Subject: **Application for Modification to Individual Section 404 Permit and 401 Certification** for the widening of US 321 from SR 1500 (Blackberry Road) to US 221 at Blowing Rock; Watauga and Caldwell Counties; State Project No. 6.739001T; NCDOT Division 11; TIP No. R-2237C, WBS Element No. 34402.2.6 Debit $570.00

This Modification request is being submitted due to the need for construction revisions at Site XII. The previous modification (authorized in 404 Permit Modification dated July 24, 2012 and 401 WQC Modification dated July 10, 2012) involved putting a "dog leg" in the pipe alignment. This current modification involves an alignment of the 84-inch pipe that more closely follows the original alignment and was determined by the contractor to be a better option. The additional stream and wetland impacts are incurred from the need to construct a bore pit for the installation of the 84-inch pipe. This modification application package consists of the cover letter, a revised EEP acceptance letter, revised Permit Sheets (including a revised Wetland Permit Impact Summary sheet that includes the modified impacts for Site XII), and the associated roadway plan sheet.

MODIFICATION (F

PROJECT REFERENCE NO.	SHEET NO.
R-2237C	19
R/W SHEET NO.	19
ROADWAY DESIGN ENGINEER	HYDRAULICS ENGINEER

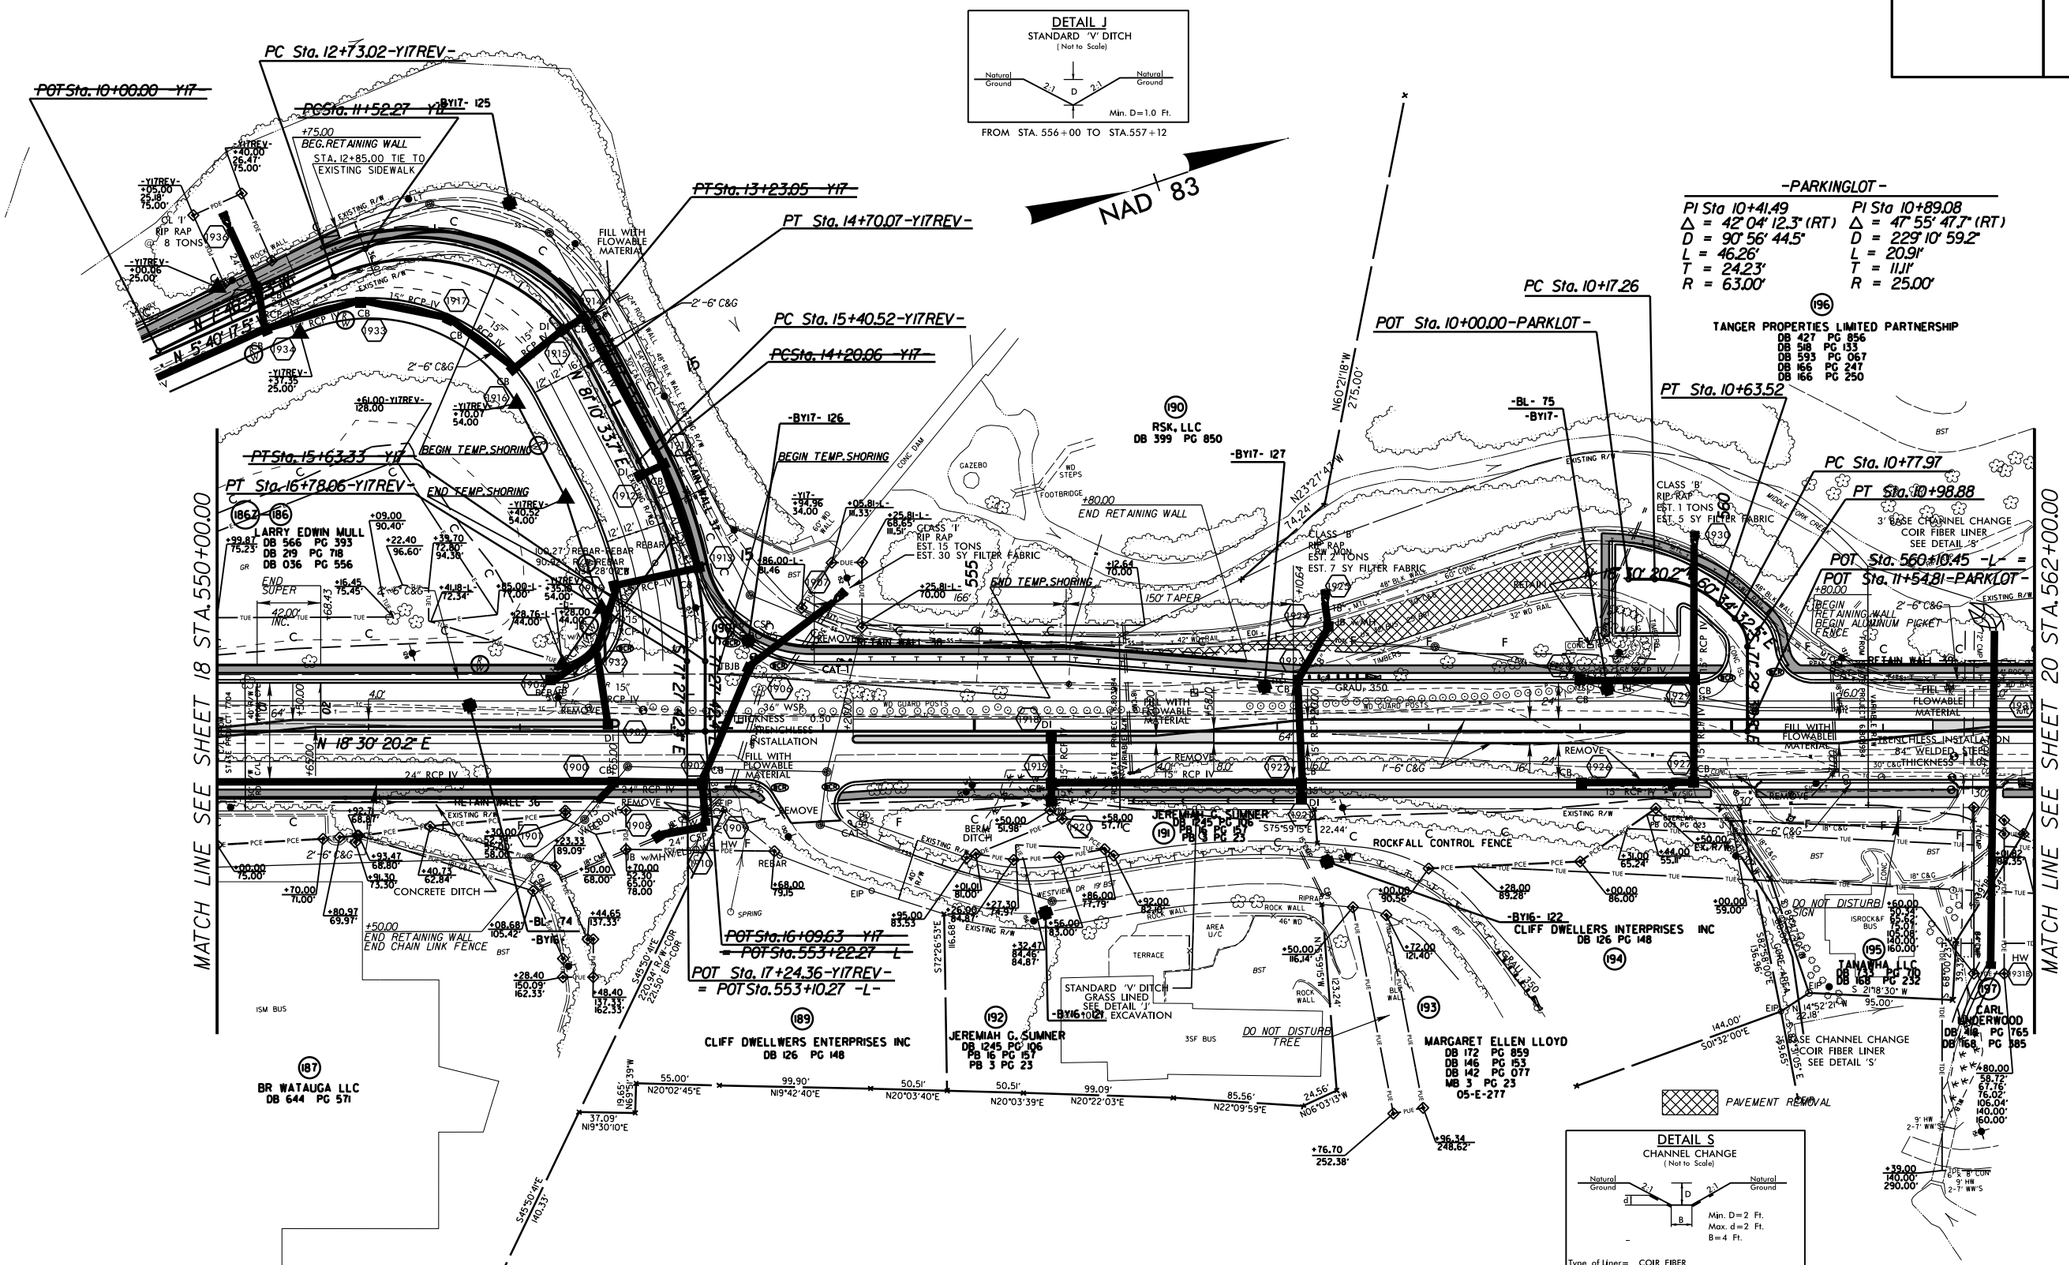
~~PI Sta 12+60.28~~	~~PI Sta 14+93.08~~
~~Δ = 88° 57' 09.9" (RT)~~	~~Δ = 27° 21' 43.9" (RT)~~
~~D = 52° 05' 13.5"~~	~~D = 19° 05' 54.9"~~
~~L = 170.78'~~	~~L = 143.27'~~
~~T = 108.01'~~	~~T = 73.03'~~
~~R = 110.00'~~	~~R = 300.00'~~

PI Sta 13+96.06	PI Sta 16+10.63
Δ = 86° 50' 51.1" (RT)	Δ = 27° 21' 43.9" (RT)
D = 44° 04' 25.2"	D = 19° 53' 39.7"
L = 197.05'	L = 137.54'
T = 123.04'	T = 70.11'
R = 130.00'	R = 288.00'

REVISIONS
R/W Revision: Revised PUE, TUE, PDE, and TDE on Parcel 195, 197 due drainage pipe revision. WTB 2/4/2014
